## ***TMS320F2802x, TMS320F2802xx Piccolo™ MCUs Silicon Revisions B, A, 0***

### **1 Introduction**

This document describes the silicon updates to the functional specifications for the TMS320F2802x and TMS320F2802xx microcontrollers (MCUs).

Figure 1. Examples of 2802x Device Markings on PT Package

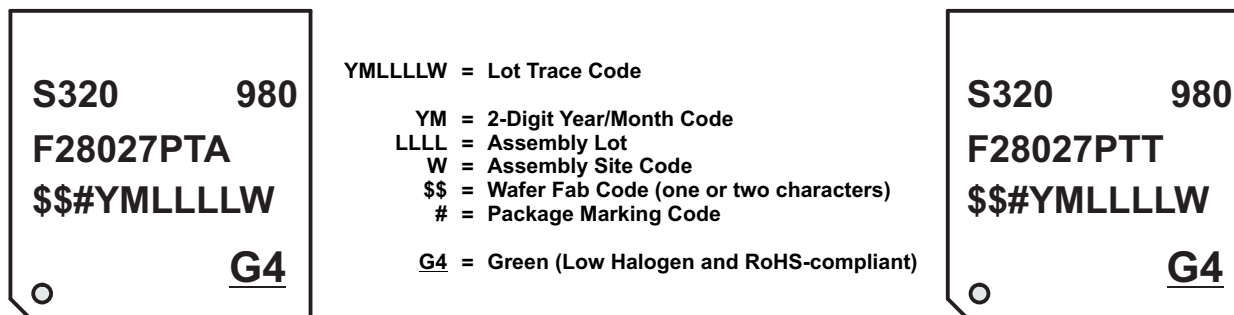
<b>Changes from January 3, 2018 to April 4, 2018 (from N Revision (January 2018) to O Revision)</b>	<b>Page</b>
• <a href="#">Figure 1</a> (Examples of 2802x Device Markings on PT Package): Updated figure. ....	2
• <a href="#">Figure 2</a> (Example of 2802x Device Markings on DA Package): Updated figure. ....	2
• <a href="#">Table 1</a> (Determining Silicon Revision From Lot Trace Code (2802x and 2802xx Devices)): Added footnote about device availability and silicon revisions. ....	2
• <a href="#">Table 4</a> (List of Advisories): Added footnote about difference between revision A silicon and revision B silicon. ....	6
